Presentation to the Advisory Committee on Reactor Safeguards

Safety Review of the North Anna Early Site Permit Application

**Presented by
Michael Scott
Senior Project Manager
New, Research and Test Reactors Program
March 3, 2005**

SSE vs RG 1.60

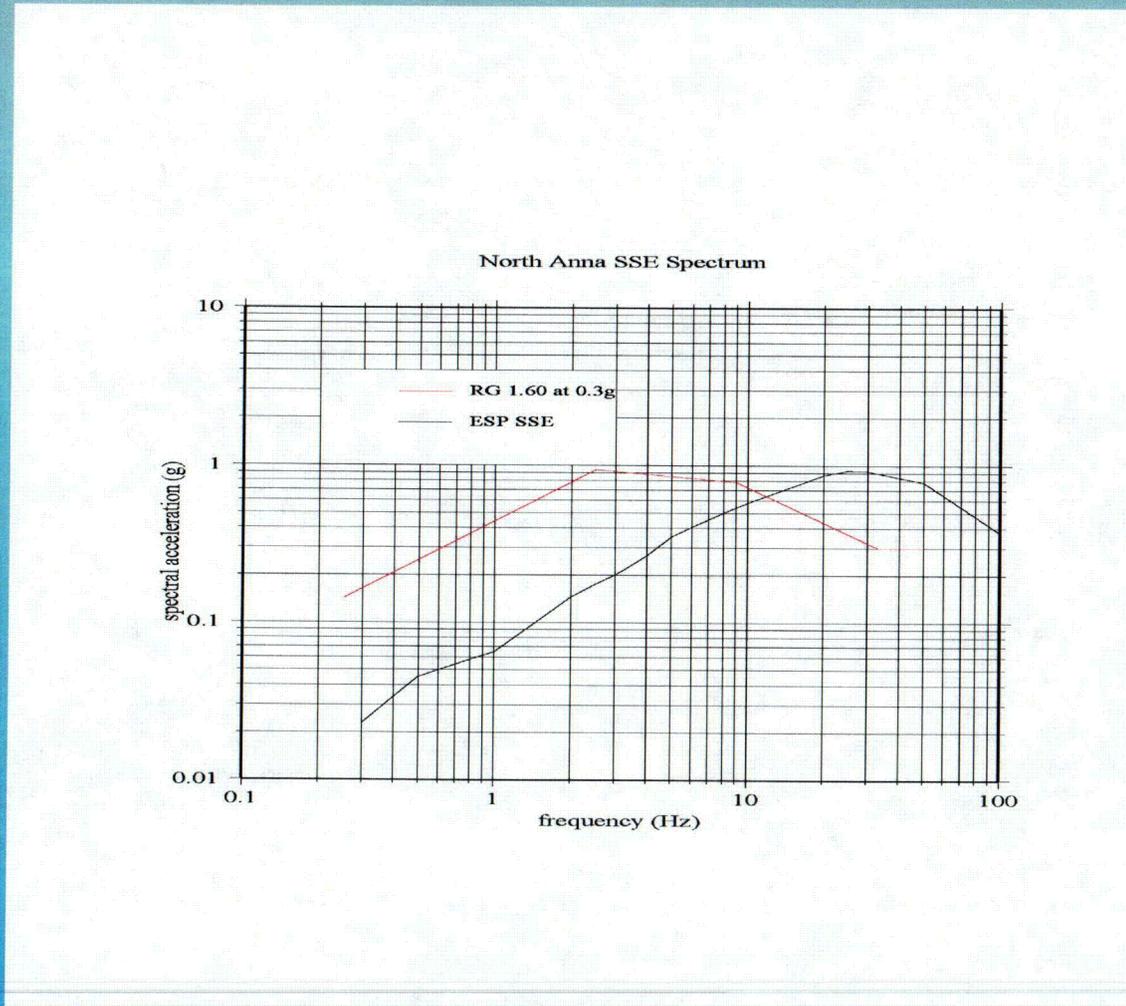
- Because North Anna is a rock site, site SSE exceeds design SSE at high frequencies for designs certified to date
- COL applicant would need to resolve disparity if one exists (dependent on design selected)
- See SSE vs. RG 1.60 diagram
